# A D D E N D U M N O . 7

**ROOF REPLACEMENT AND RELATED WORK  
WESTERN ELEMENTARY SCHOOL  
NAUGATUCK, CT  
KBA #15037.00**

Date: February 17, 2016  
Page: 1 of 1

DATE: 2/17/16	DRAWN: CC	DRAWING NO.:
SCALE: N.T.S.	PROJECT NO.: 15037.00	<b>SKA7.01</b>

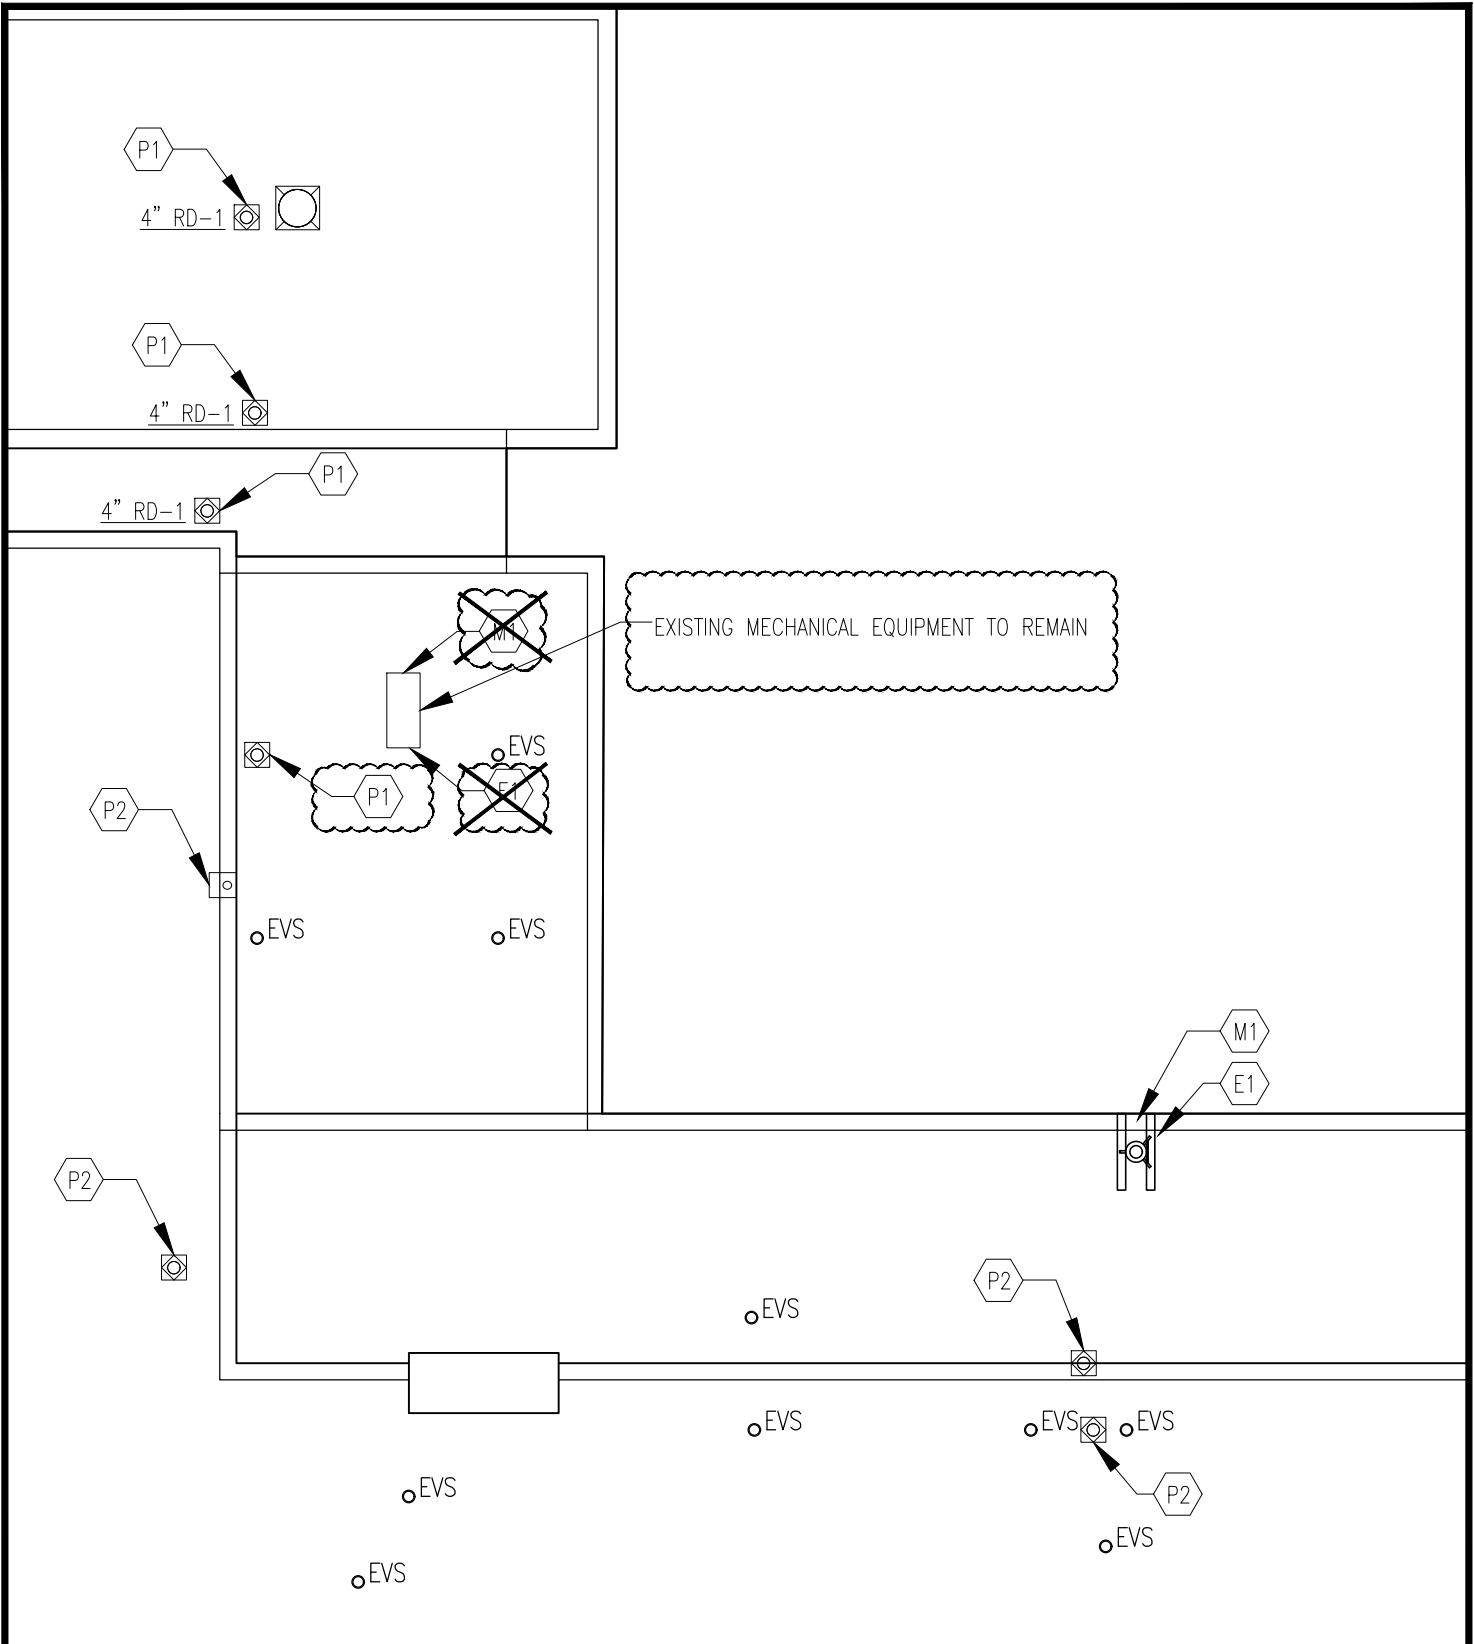
The existing make-up air unit on kitchen roof is not scheduled to be removed. See sketch SKA7.01.

EXISTING MECHANICAL EQUIPMENT TO REMAIN
